Wollongong Local Planning Panel Assessment Report | 24 September 2020

WLPP No.	Item No.1
DA No.	DA-2019/1462
Proposal	Demolition of existing structures, retention of heritage hotel and construction of a mixed use (Commercial / Residential) development
Property	98-110 Princes Highway DAPTO
Applicant	ADM Architects
Responsible Team	Development Assessment and Certification - City Wide Team (KR)

ASSESSMENT REPORT AND RECOMMENDATION

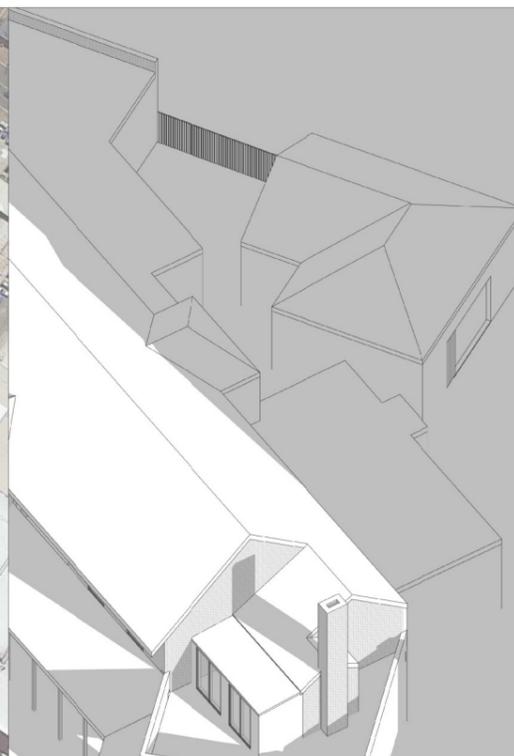
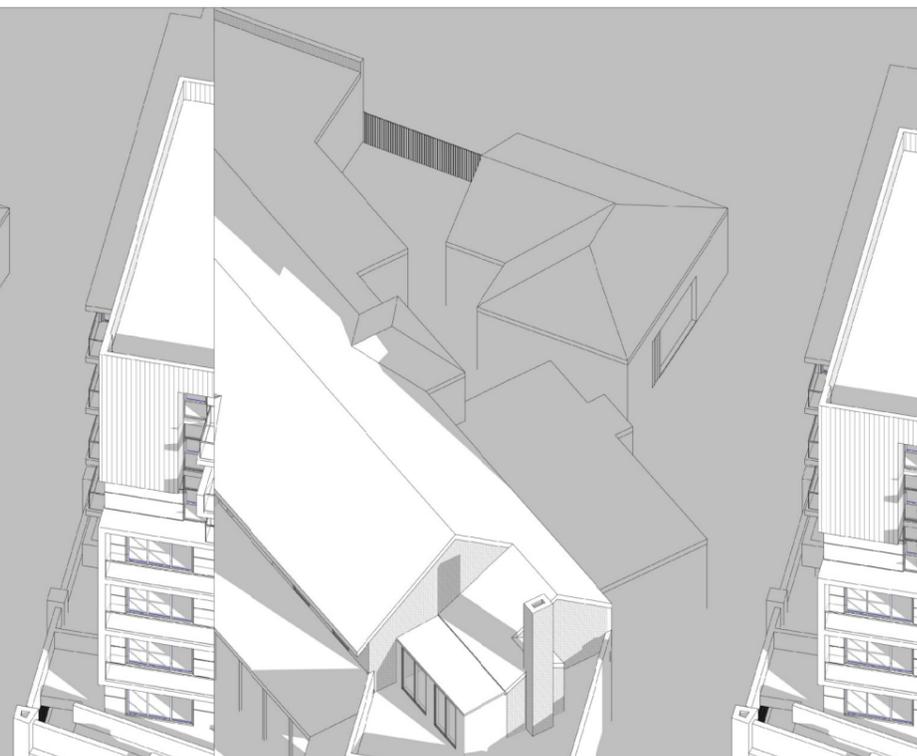
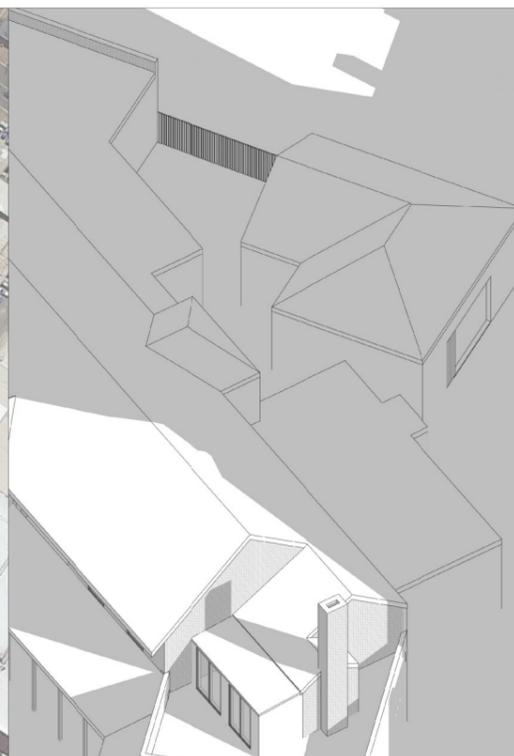
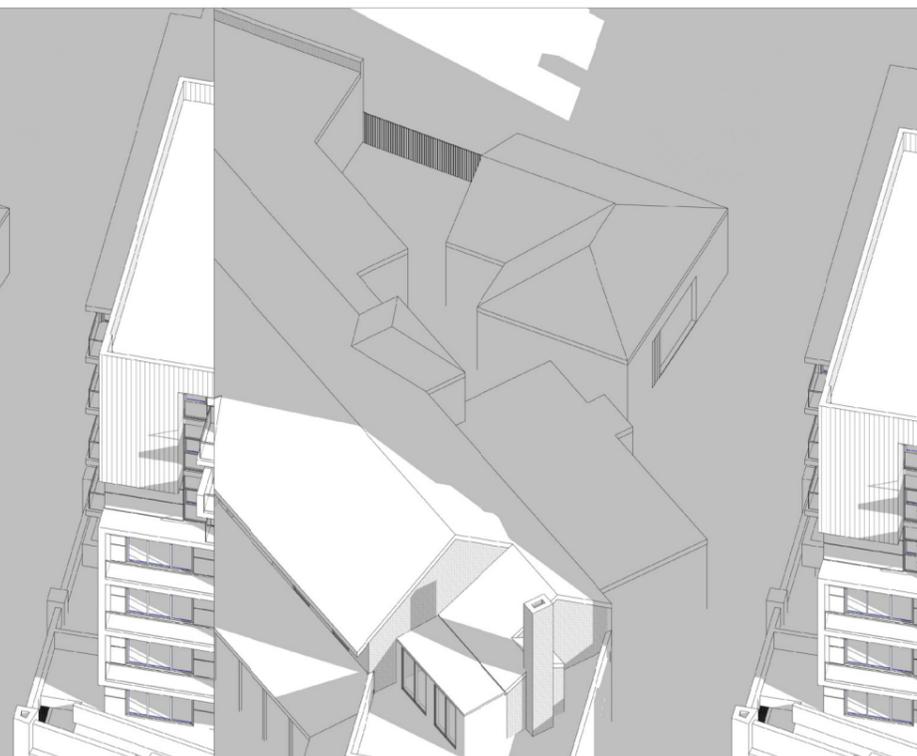
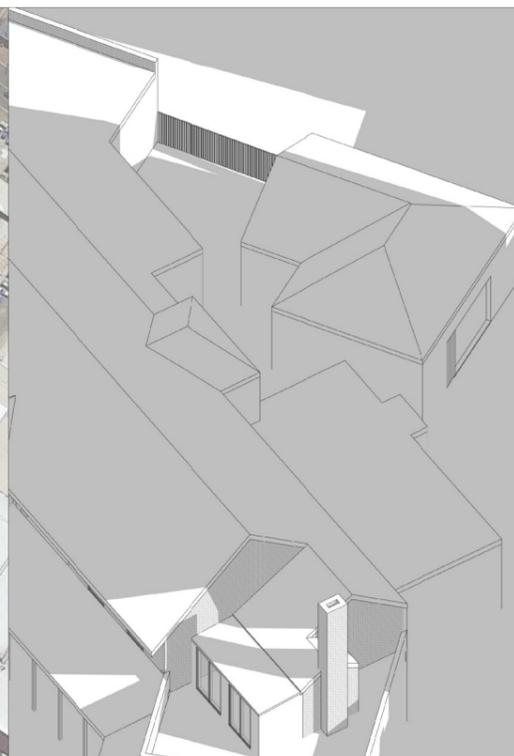
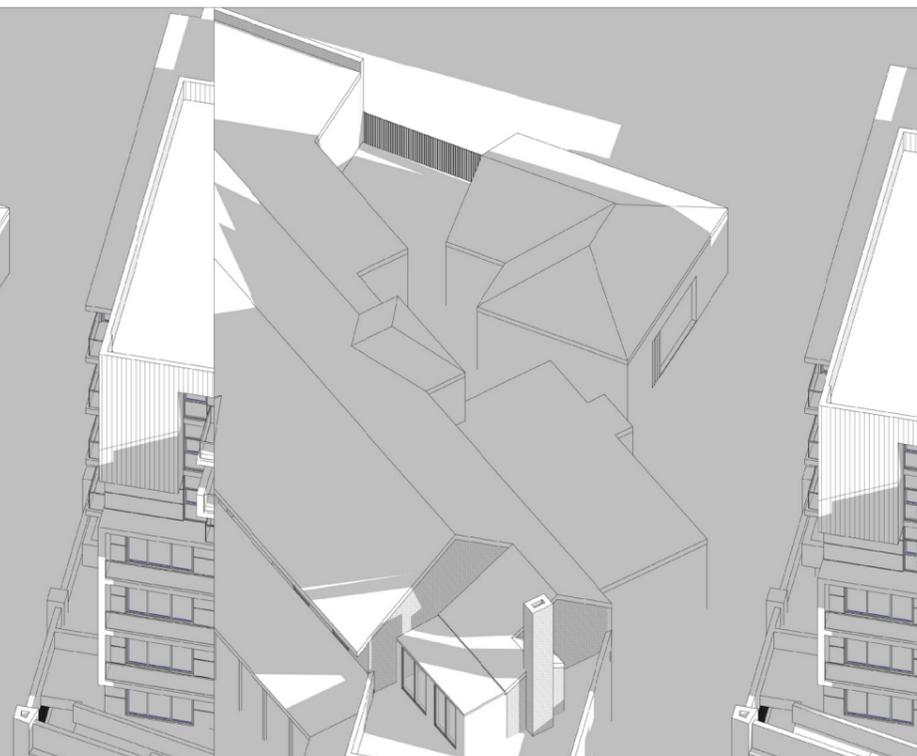
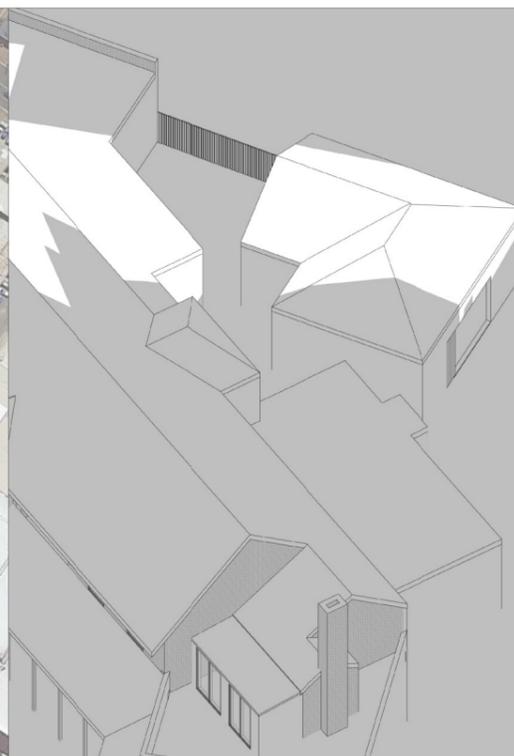
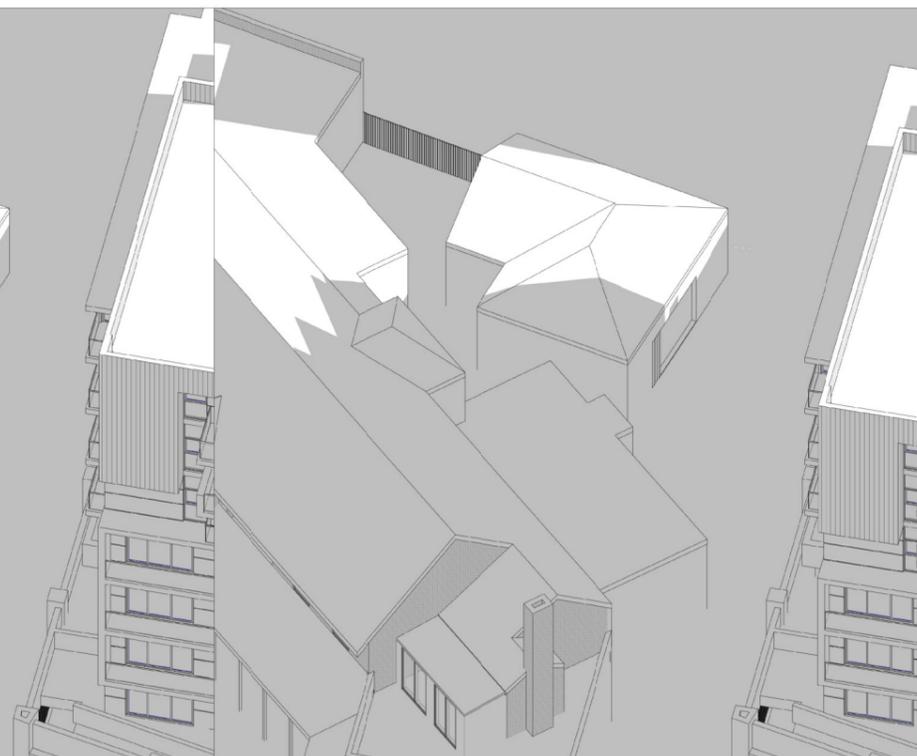
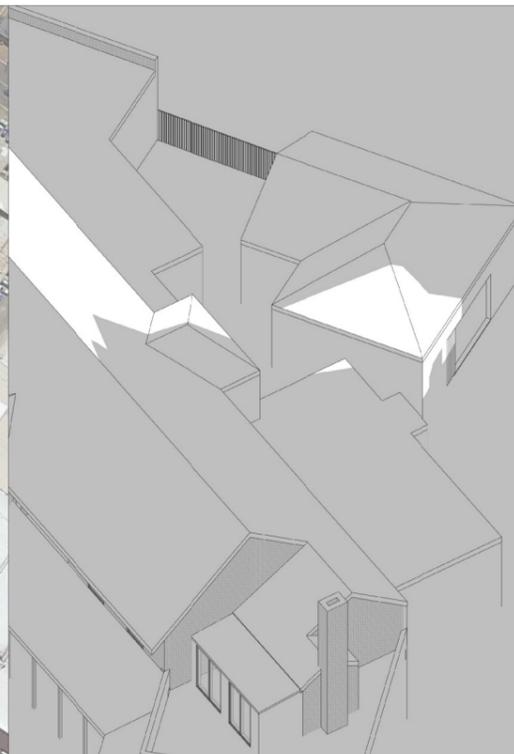
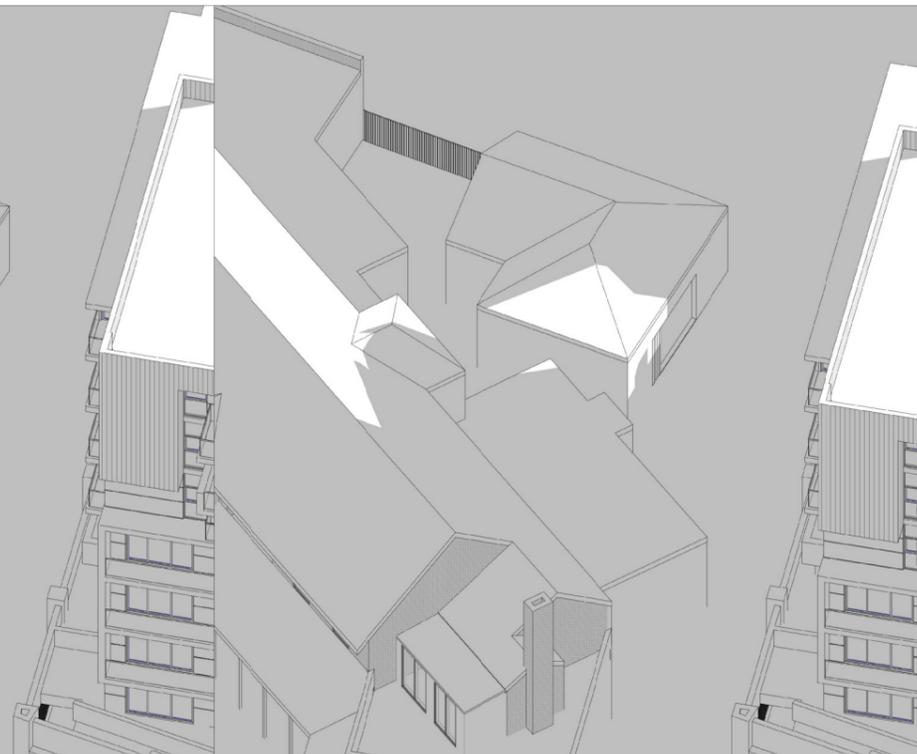
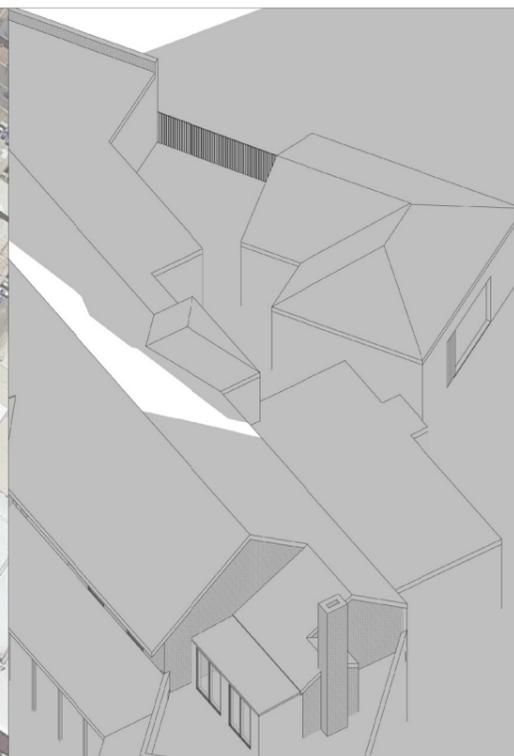
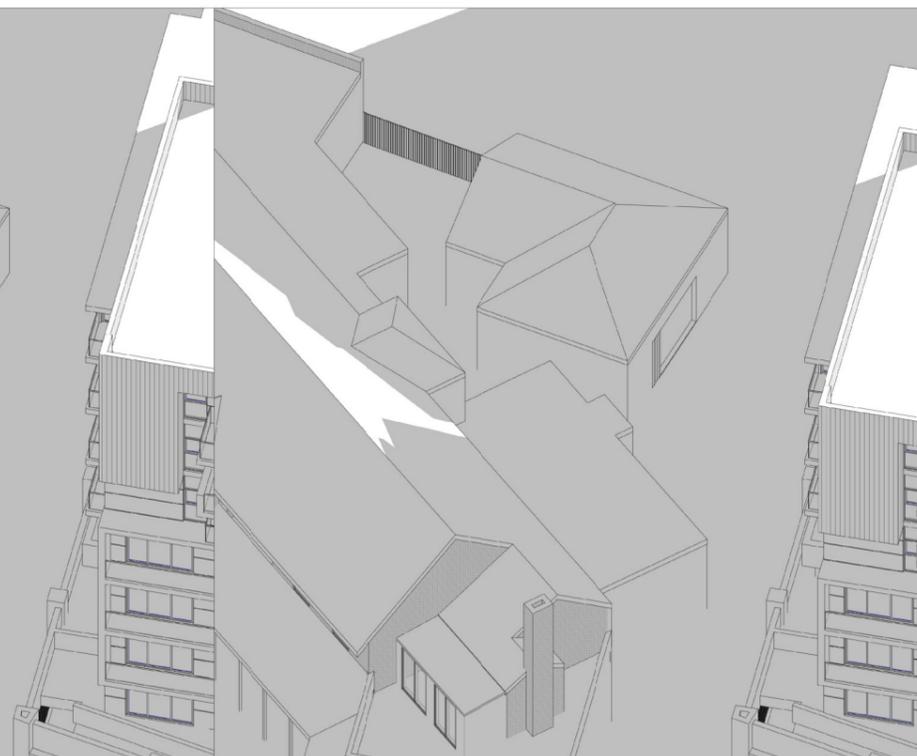
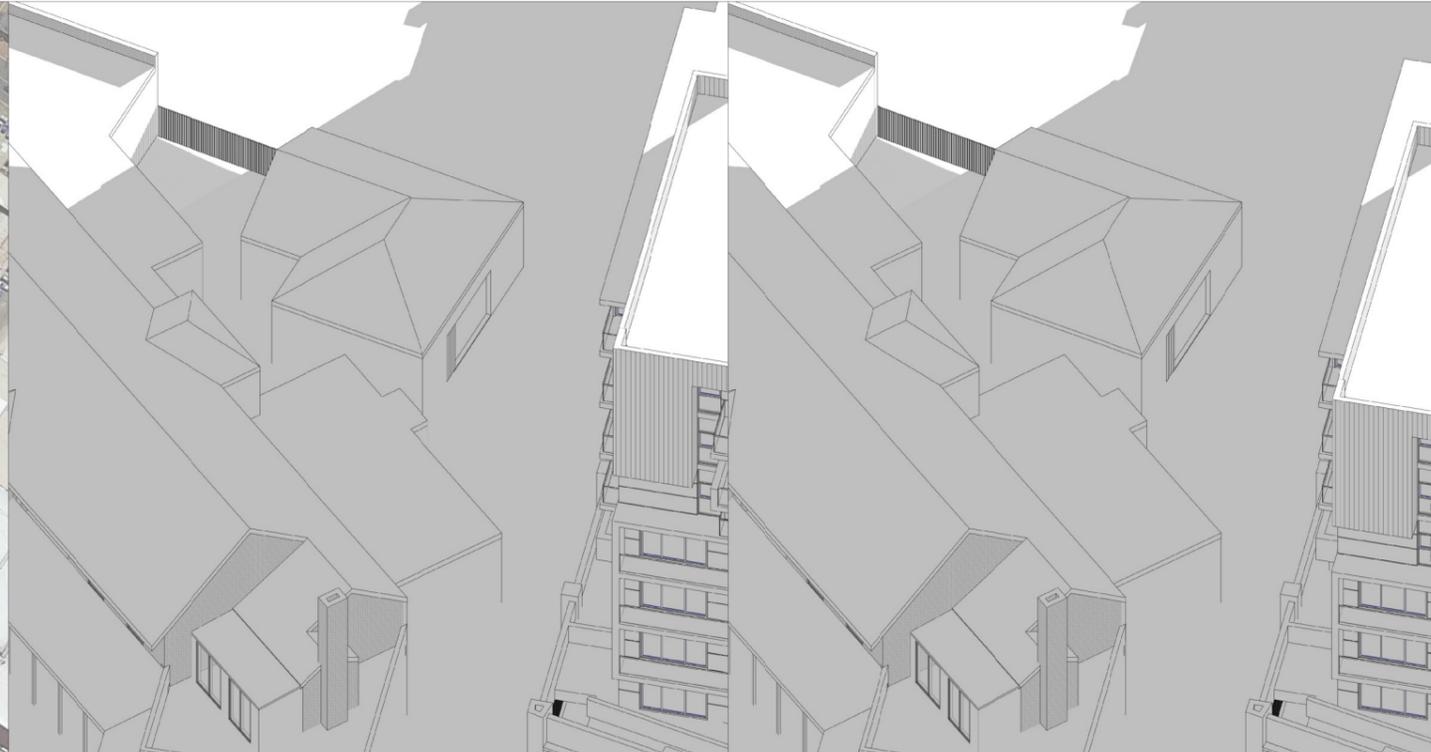
The submitted shadow diagram demonstrates that the proposal would overshadow the Dapto Hotel at all times of the day in mid-winter. The overshadowing impacts on the Hotel site are not supported by Council's Heritage Officer. The bulk and separation should be modelled to show how increased solar access of the Hotel Site can be better achieved.
